ADDENDUM

PROJECT: Jefferson Community Health Center
Patient Wing and Administration Renovation
Fairbury, Nebraska

AD-2

DATE ISSUED: Friday, January 25, 2013

Electrical Demolition Plan

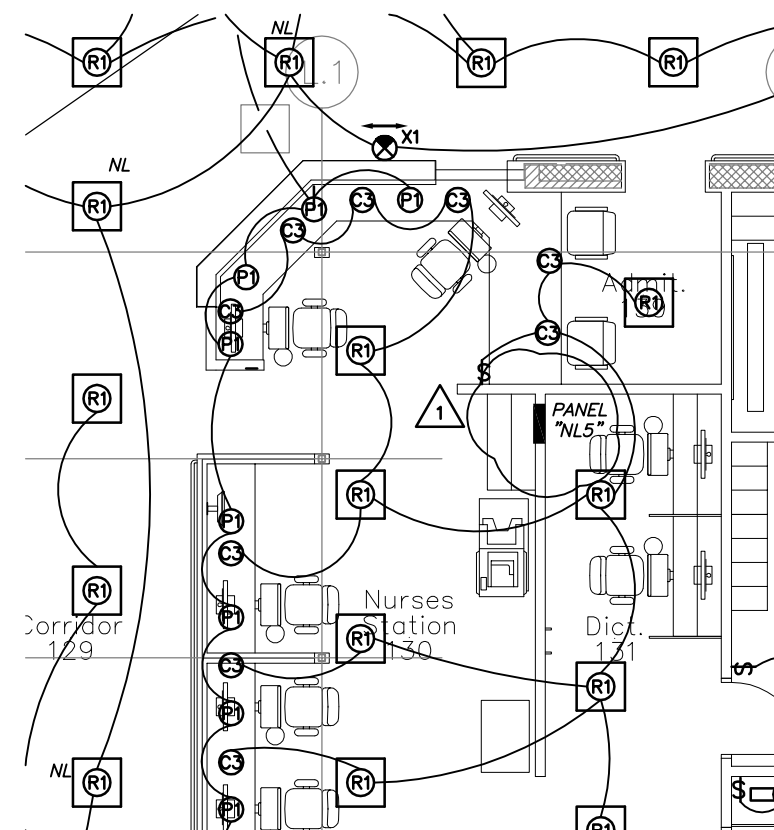
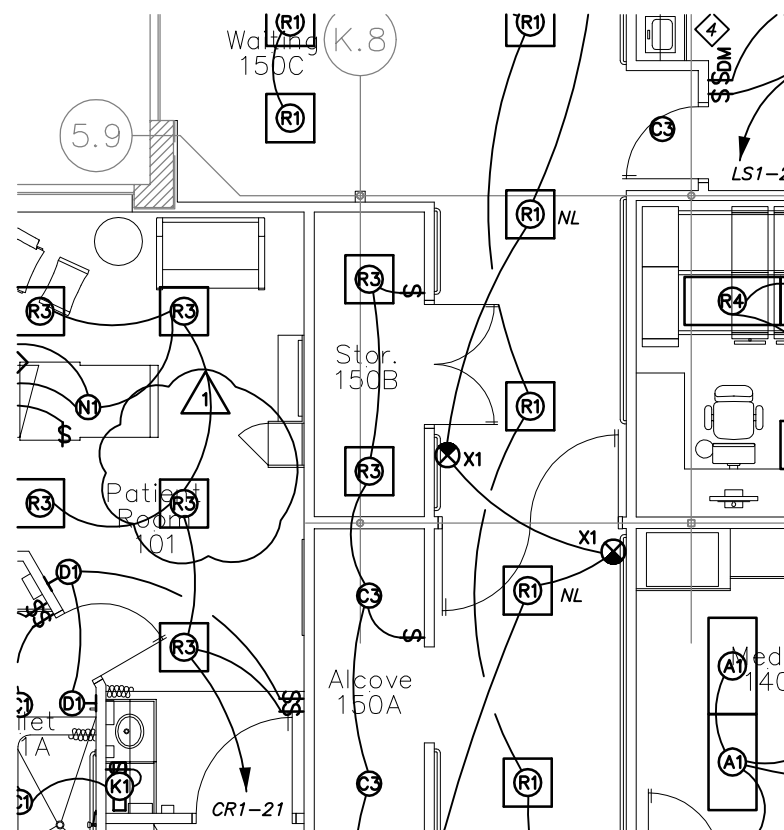
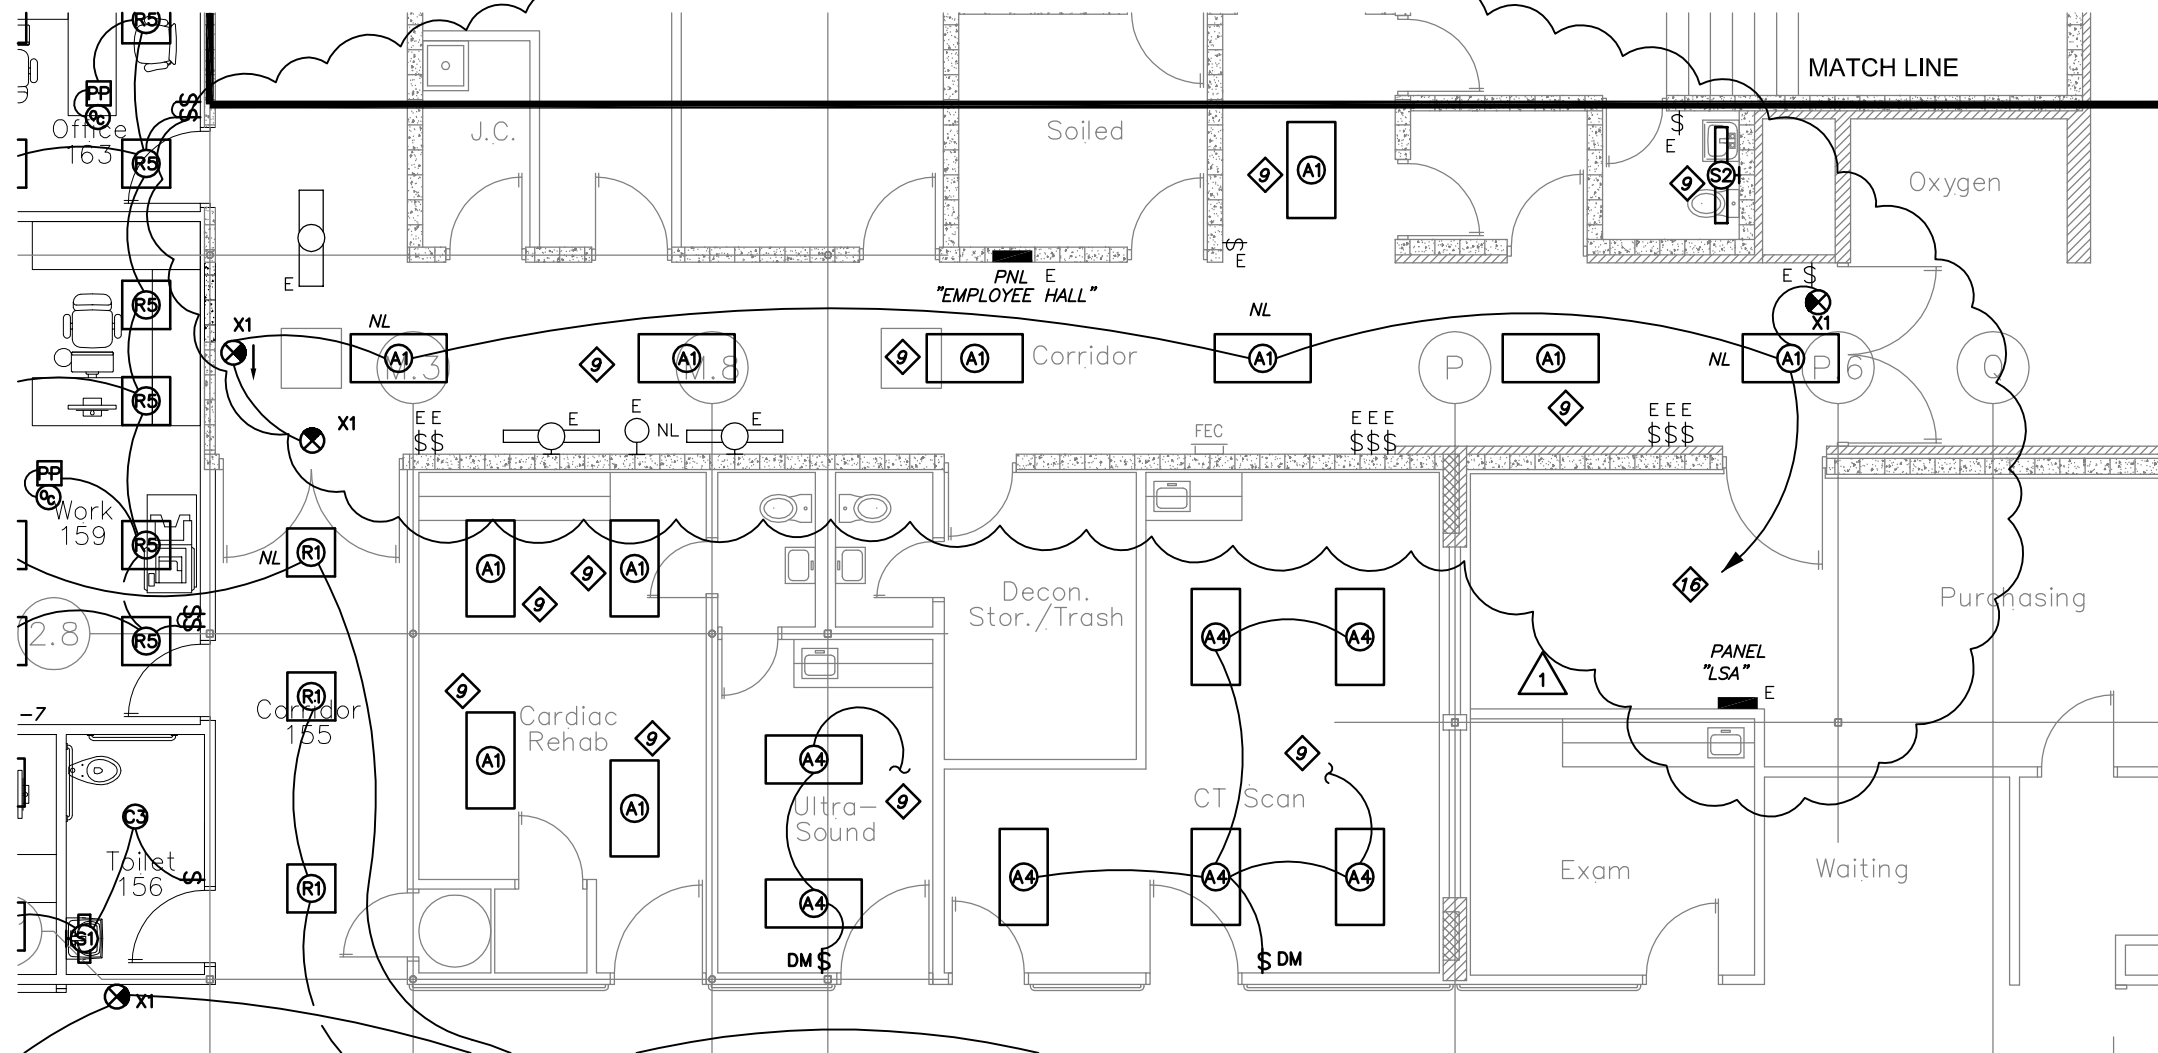
In reference to Sheet ED-102, see attached Sheet ED-102.1 for added demolition and revised notes.

Lighting Plan

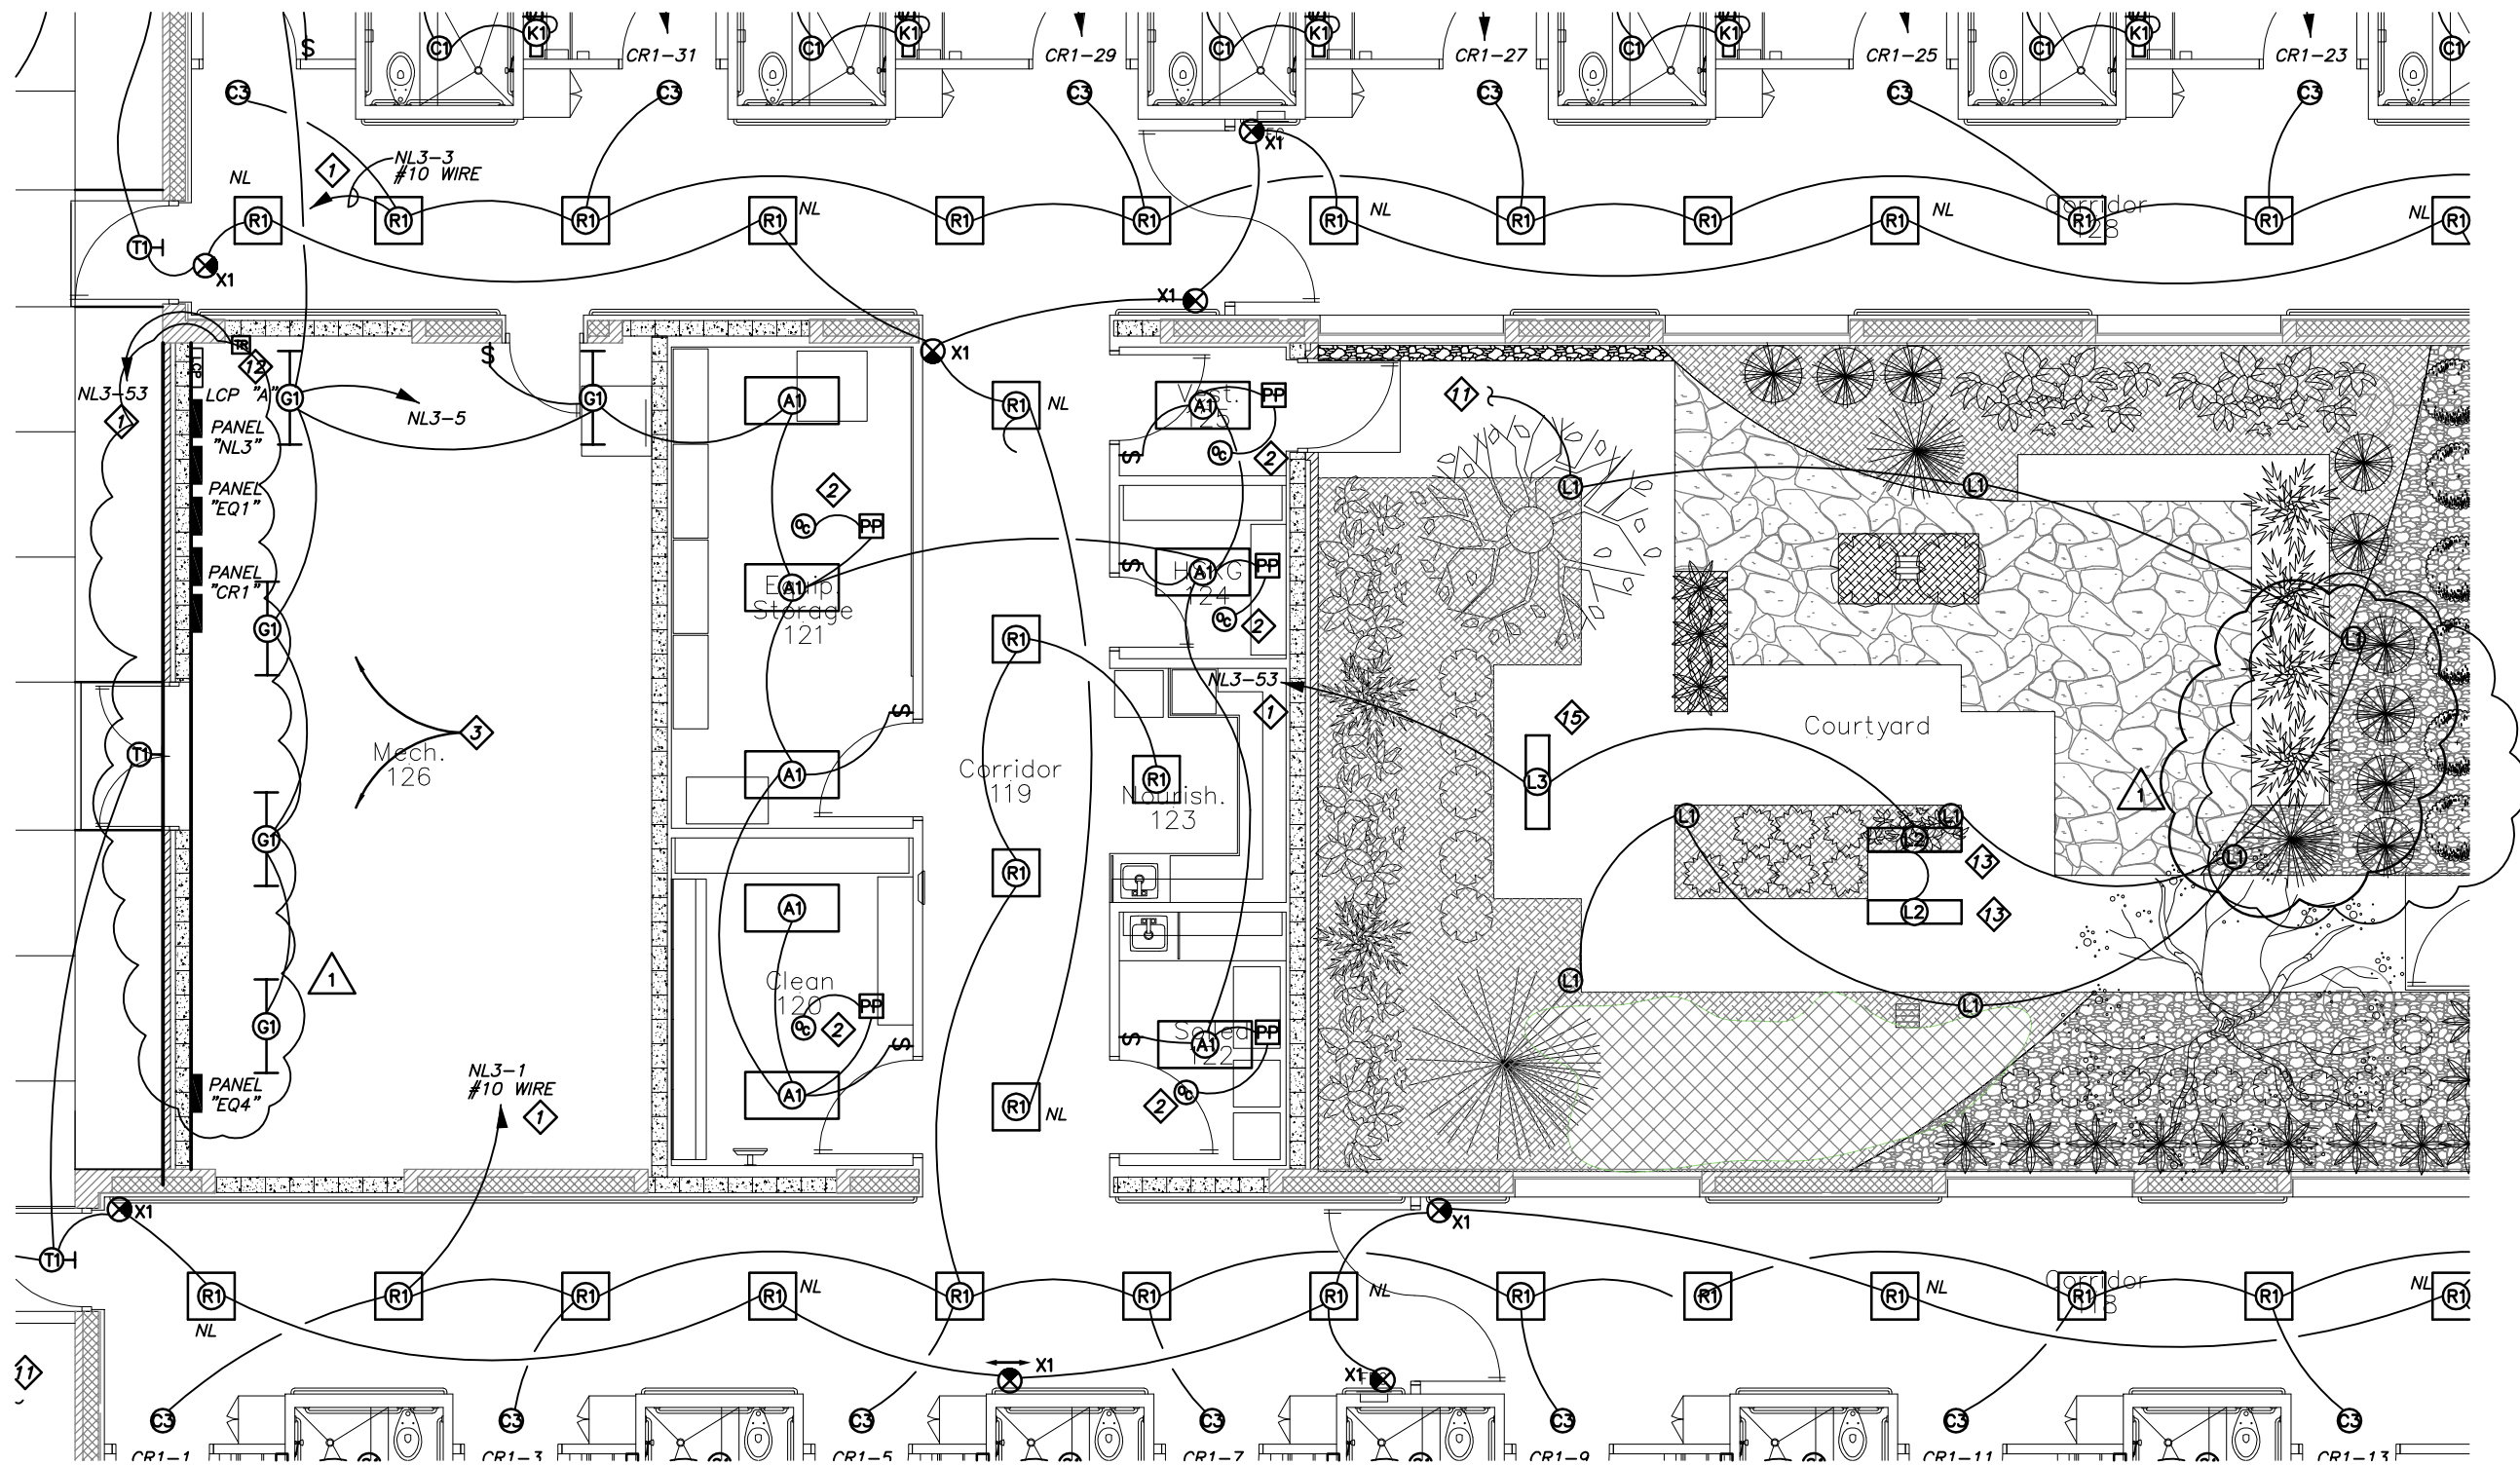
In reference to Sheet E-101, see attached Sheet E-101.1 and E-101.2 for revised lighting plan, Greengate is a approved manufacture of lighting control panel and occupancy sensors.

In reference to Sheet E-101, note the following:

Fixture type in Rooms 149A and 149B is to be "A3."

In Room 117A, fixture type above the tub is to be "C1."

In Room LDR 117, Fixture Type to be "F1."

In Reading 152D, Fixture Type to be "R6."

Power Plan

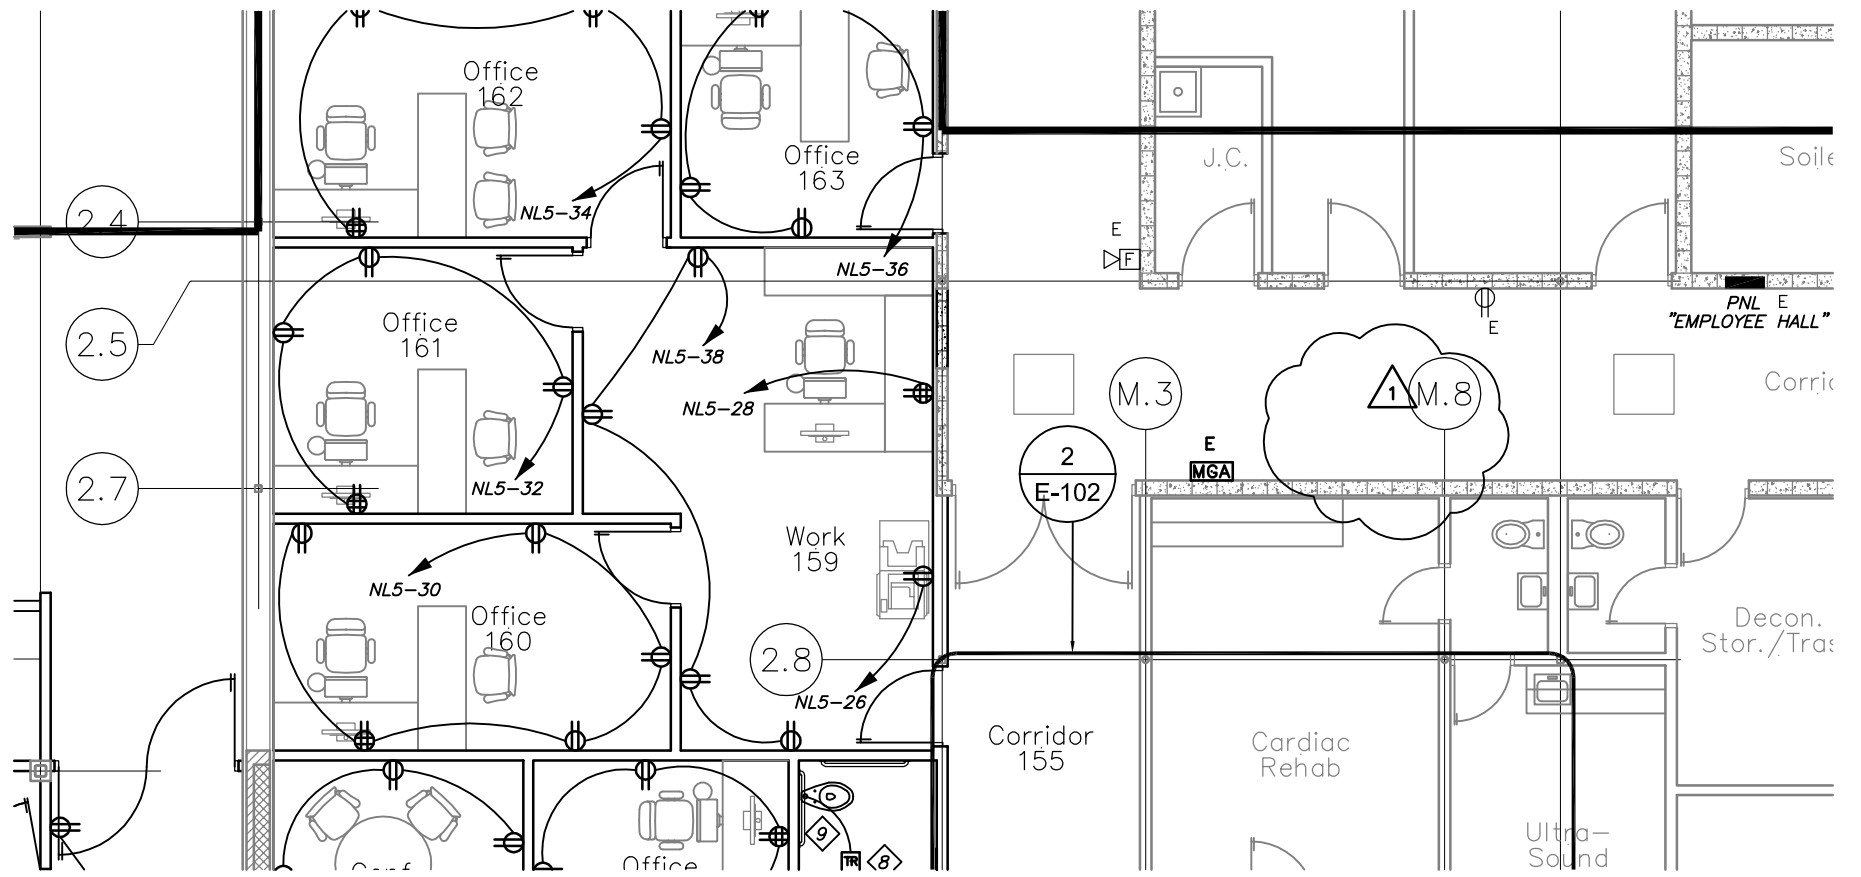
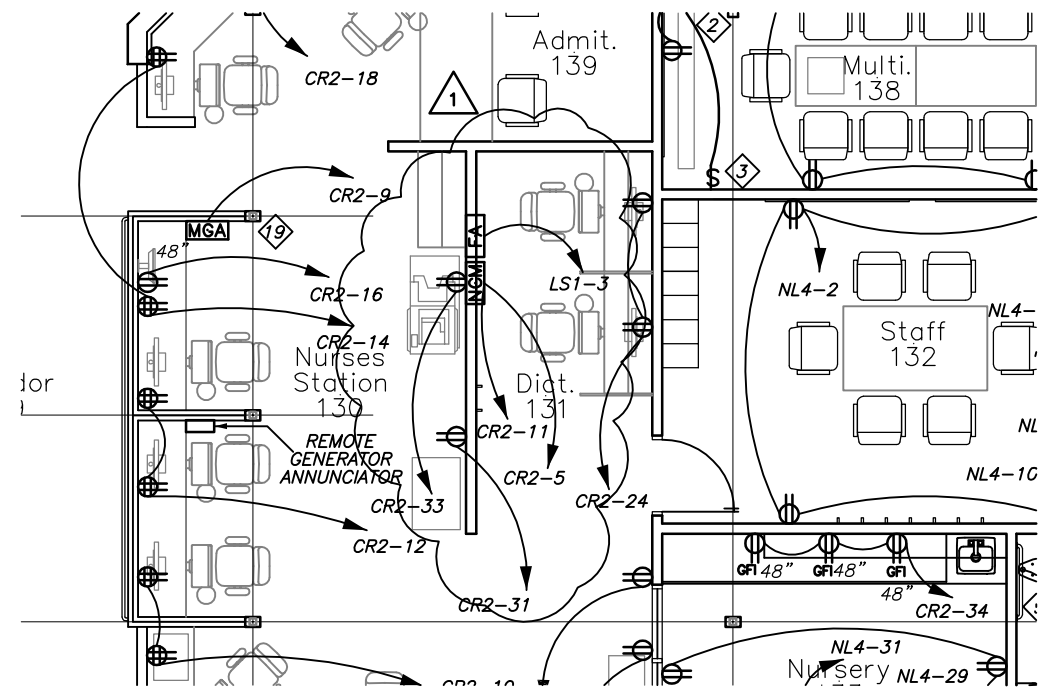
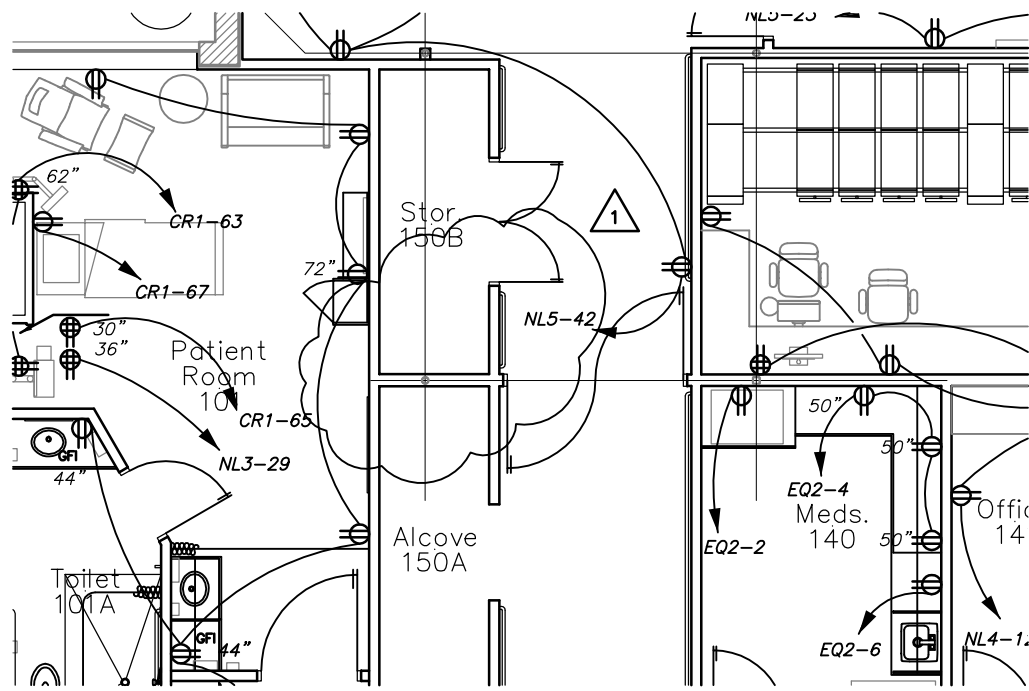
In reference to Sheet E-102, see attached Sheet E-102.1 for revised power plan.
